Webster University
Interdisciplinary Science
Building

TECH ELECTRONICS The Power of Connection and Protection® St. Louis, Missouri Chicago, Illinois Columbia, Missouri Indianapolis, Indiana Springfield, Missouri www.techelectronics.com 1.800.831.789	
PROJECT NAME / CUSTOMER / LOCATION: WEBSTER UNIVERSITY INTERDISCIPLINARY SCIENCE BLDG. WEBSTER GROVES, MO 63119	
SYSTEM DESCRIPTION: FIRE ALARM SYSTEM	
DESIGNED BY: KH	DATE: 11/11/16
CHECKED BY: VK	PROJECT XREF: P11608310005
INSTALLED BY: VK	DATE: 11/11/16
	PROJECTED BY: FA-E0101-A

Shop Drawing Submittal Review

E0103.B

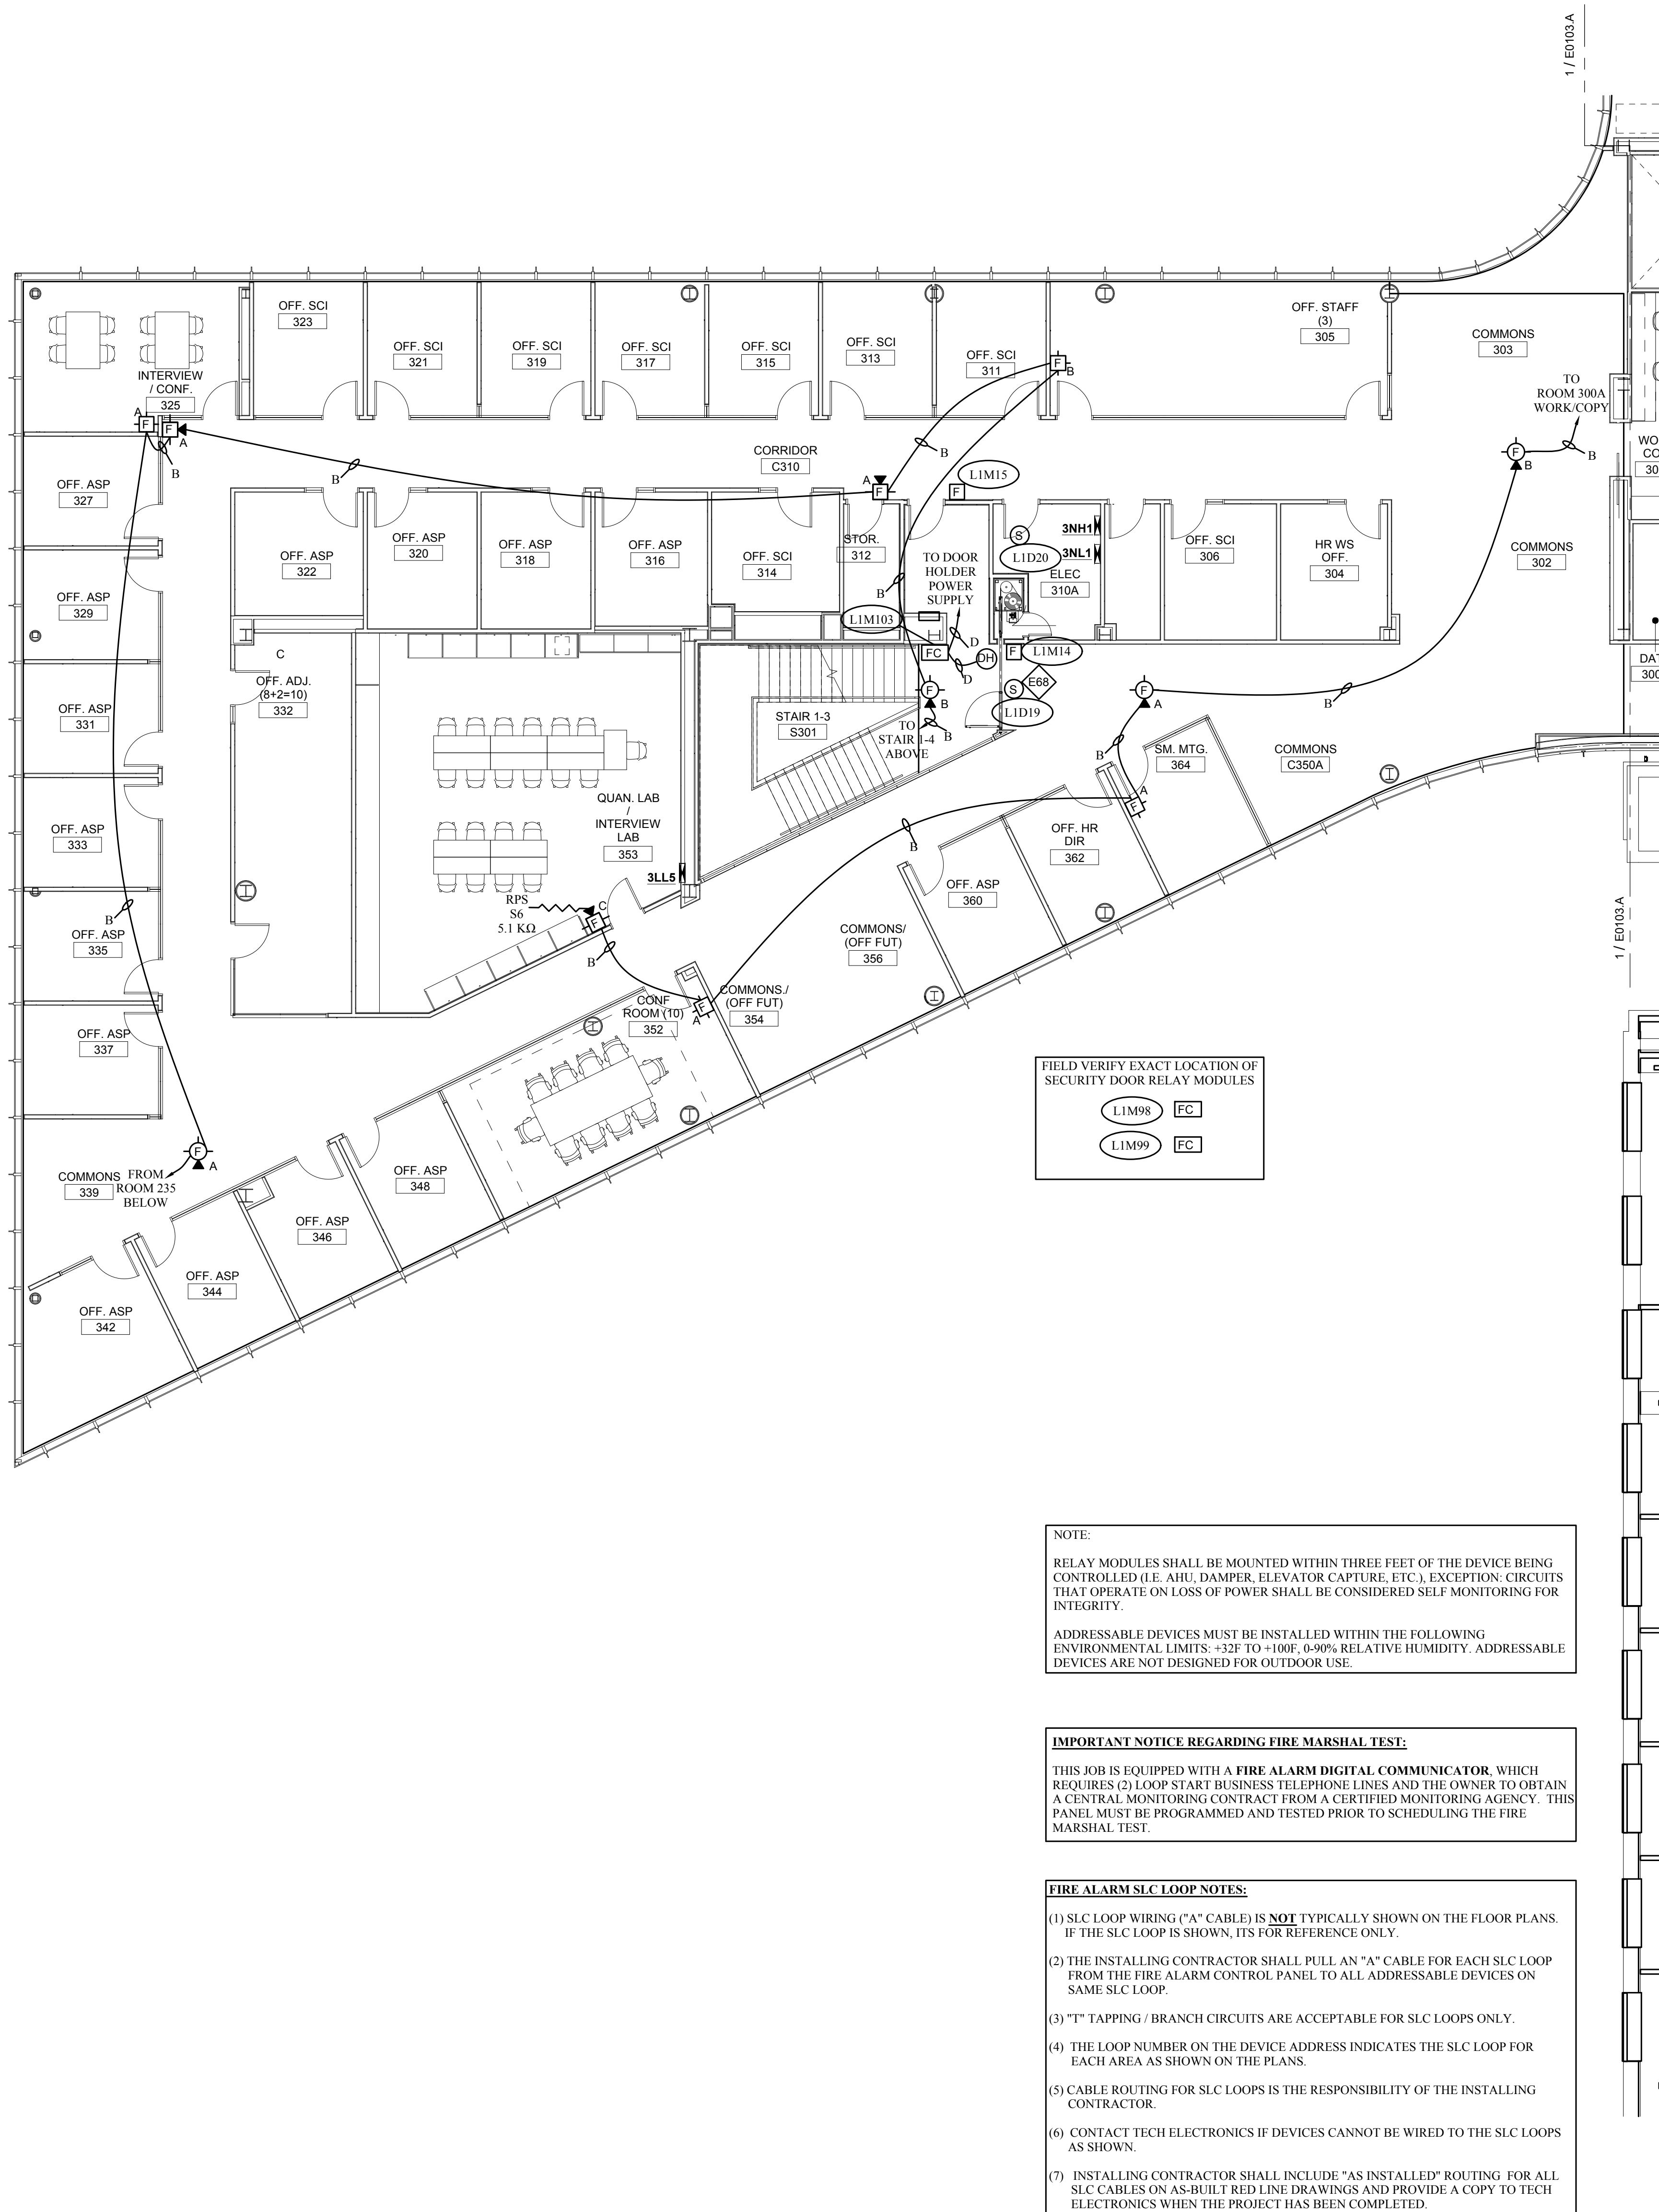
Provide a strobe in room 332 (Off. Adj.) as shown on drawing E0103.B
